UNITED STATES  
NUCLEAR REGULATORY COMMISSION  
WASHINGTON, D.C. 20555-0001

February 7, 2014

SUBJECT: BRAIDWOOD STATION, UNITS 1 AND 2, AND BYRON STATION, UNIT NOS. 1 AND 2 - ISSUANCE OF AMENDMENTS REGARDING MEASUREMENT UNCERTAINTY RECAPTURE POWER UPRATE (TAC NOS. MF2418, MF2419, MF2420, AND MF2421)

Effect of flatness ratio (FR) change on meter factor (MF)

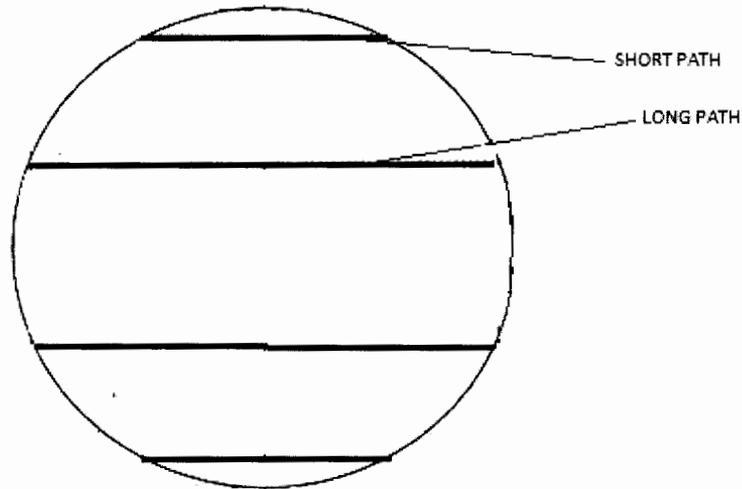
Estrada provided FR changes during a seven month period starting in May, 2011. Using these data, the NRC staff estimated the predicted thickness changes would change flow rate by less than 0.01 percent, in agreement with Cameron's conclusion. This is not a likely cause of the observed behavior.

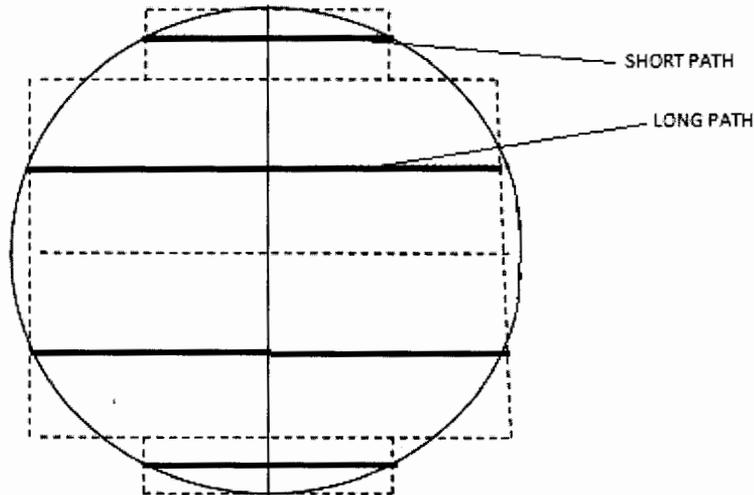
FR can be determined experimentally, such as by testing at ARL where the CheckPlus LEFM will provide the velocity data.

Once the V's are determined, the flow rate determined by the CheckPlus LEFM can be calculated by multiplying the rectangular vertical widths (weighting factors) indicated in the following figure by the dash lines by the corresponding velocities times two:

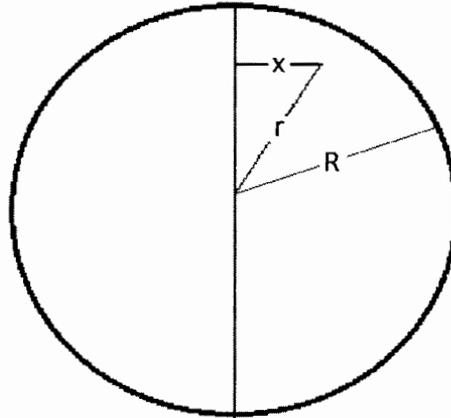
FR and MF can also be calculated using an assumed symmetric velocity distribution that is a function of pipe radius, expressed as  $V(r)$ , where  $r$  is the reduced radial position with the origin at the pipe centerline and  $0 \leq r \leq 1$ . Since the CheckPlus LEFM determines a mean

velocity along the path, the calculation must be based on the same path, as illustrated by the "x" dimension in the following figure:

where the mean velocity is calculated by  $1/X \int_0^X V(x) dx$  where  $x=X$  at  $r=R$  and  $V(x)$  is determined from the assumed  $V(r)$  where the relationship between  $x$  and  $r$  is obtained from the geometry illustrated in the figure.

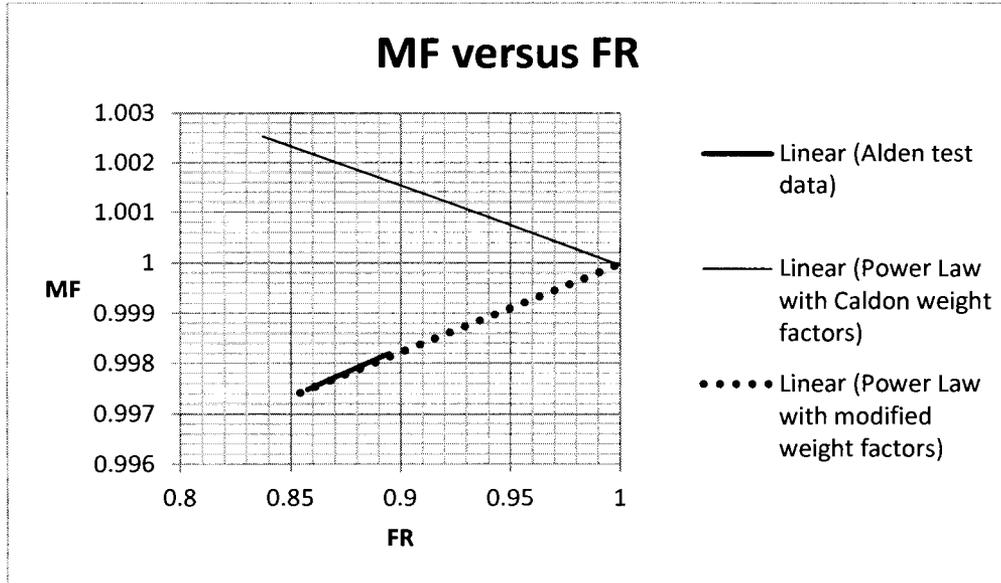
Nominal number of increments	Calculated relative short path velocity	Calculated relative long path velocity	Calculated relative FR	Calculated relative MF
1000	1.0000	1.0000	1.0000	1.0000
500	1.0000	1.0000	1.0000	1.0000
250	1.0001	1.0001	1.0000	1.0001

The calculations using 1000 increments do not introduce a significant numerical error.

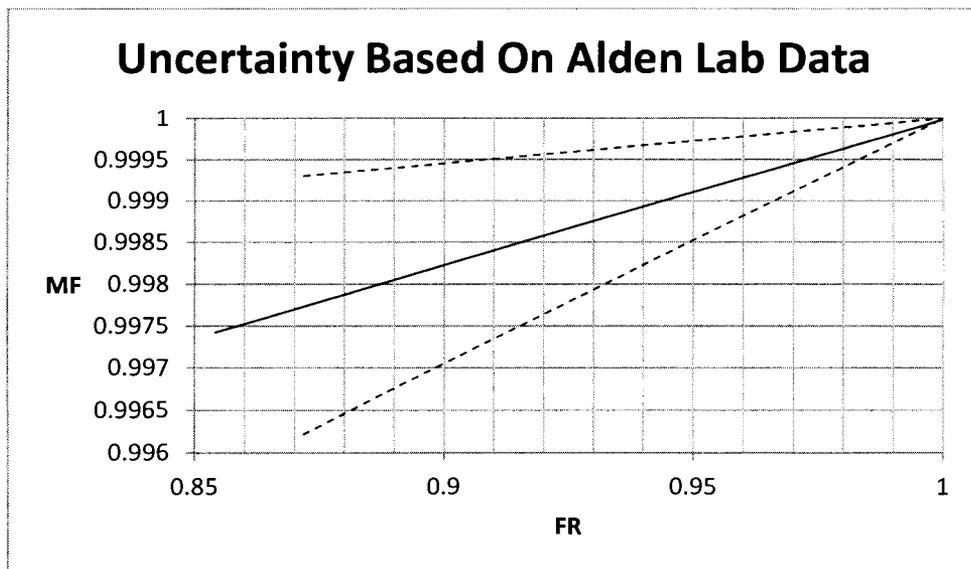
The above calculations were based on nominal test values without considering the ARL flow rate uncertainty. There is significant scatter in the 16 data points, in part due to testing different configurations to bracket possible variations introduced in the plant installation. Simply obtaining the standard deviation,  $\sigma$ , without considering variation in FR, approximating uncertainty as two times  $\sigma$ , and applying the uncertainty at the mean FR of the data provided the following approximation of the data scatter. Note that the upper extreme never reaches MF = 1 except at FR = 1 in contrast to the Caldon extrapolation of the data to the Caldon calculation that Caldon used to evaluate MF sensitivity. Further note that Caldon's approach results in a reduction in MF with increasing FR whereas the Alden data establishes that MF increases with increasing FR. In contrast, the absolute magnitude of the MF changes is identical due to the mirror image of the two calculations with respect to MF = 1.

The NRC staff used its Excel spreadsheet to calculate the velocity distributions and effect on MF that corresponded to the observed FR's provided by Estrada for the May 2011, to November 2011, FR's. The conclusion from the NRC staff study was that, regardless of which approach is used (which changes the curve that applies), the change in FR that occurred between May and September 2011, is predicted to introduce a maximum change in MF of about  $6 \times 10^{-6}$  which is negligible. Stated differently, the NRC staff concludes that the CheckPlus LEFM calibration is not calculated to have changed by more than about  $6 \times 10^{-4}$  percent. Further, an important consideration for determining the significance of Byron Unit 1 trend is that the test data included the expected plant configuration and modifications that caused swirls that were greater than observed during plant operation. Therefore, the NRC staff concludes that the Byron Unit 1 trend was not significant.
